Technical review example

Triclamp LV Bushing

Awaiting tank drawing

Tank hole and bolt arrangement, redrawn from the published product PDF.

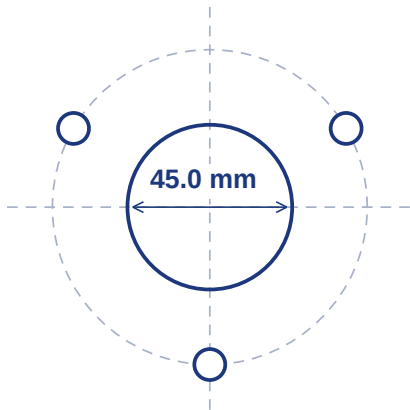
Confirm the proposed opening against the original product reference.

Check hole positions and spacing against the supplier's mounting requirements.

Provide the tank wall thickness for supplier review.

Does the proposed tank drawing match the supplier's mounting requirements?

Pending receipt of the tank drawing and supplier confirmation.
